STATE OF WASHINGTON
STATE BUILDING CODE COUNCIL

Log No. 077
Proponent Revision
5/20/22

Section(s):
WSMC 401.4

Title:
Intake Opening Location

Building 1:

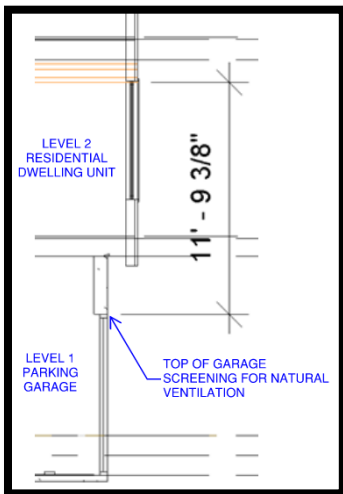
Parking garages are each an Open Parking Garage as classified in 2018 WSBC Section 406.5.2 and will be naturally ventilated. The top of the garage screening for natural ventilation is located the following vertical distance (by building) from the mechanical intake on Level 2 above, which all exceed the 5 ft separation distance as required by ASHRAE Standard 62.1-2016:

- Building 1: 11'-9"
- Building 2: 12'-5"
- Building 3: 12'-4"

Plan view of parking garage layout with outline of residential units above (dashed line) illustrating 10 ft horizontal separation cannot be met:

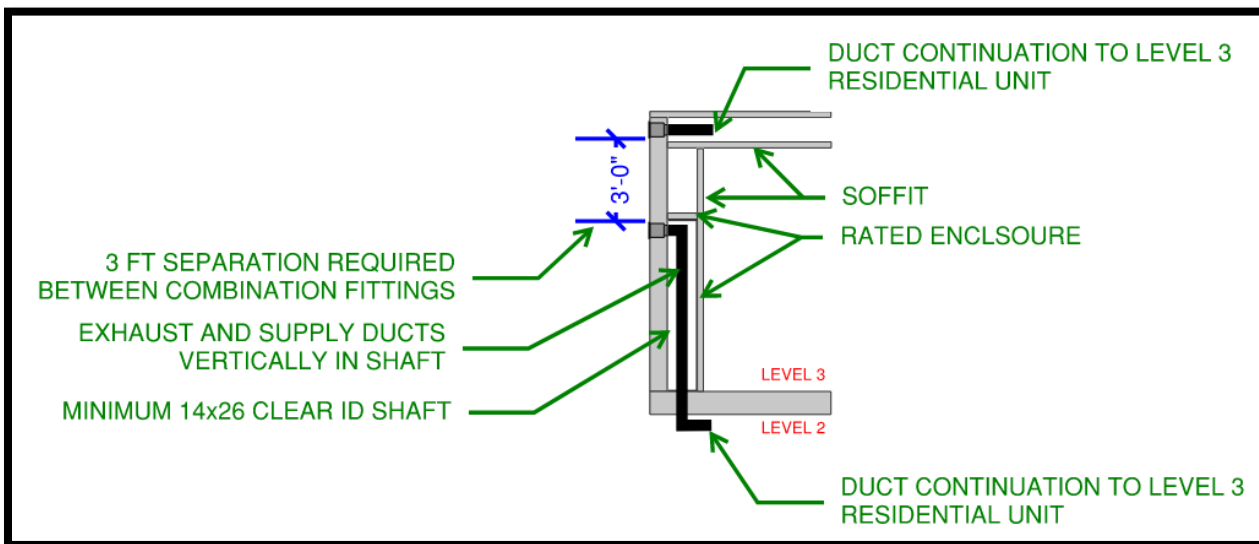
This project includes three 4-story multifamily apartment buildings where the majority of the ground floor is residential parking in an open, naturally ventilated garage with residential units on the levels above. The floor heights do not allow for either 25 feet vertical or 10 feet horizontal separation as required by 2018 WSMC Section 404.4.2 without the outdoor air intakes for Level 2 units being located on Level 3 above.

Detail of outdoor air intake for Level 2 unit from Level 3 above to achieve IMC 25 feet vertical separation:

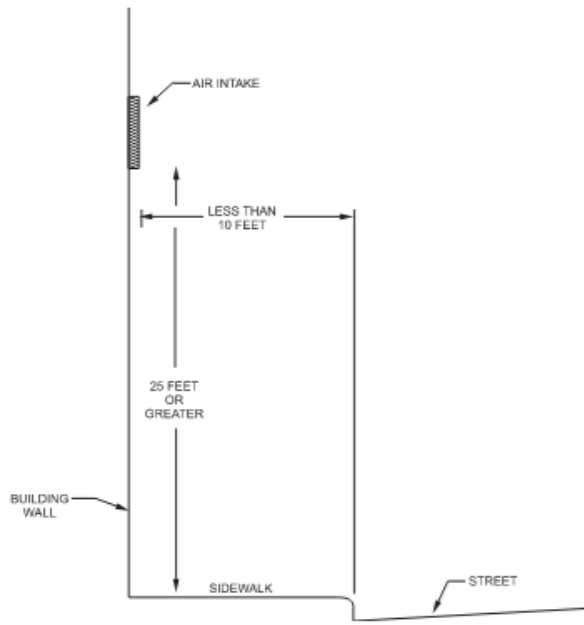
For residential projects there is a cost savings of \$500-\$1000 per residential unit to not provide “snorkel” outdoor air duct up to the floor above. Cost savings include ductwork, duct insulation, rated enclosure to separate duct from floor above or fire damper in floor above.
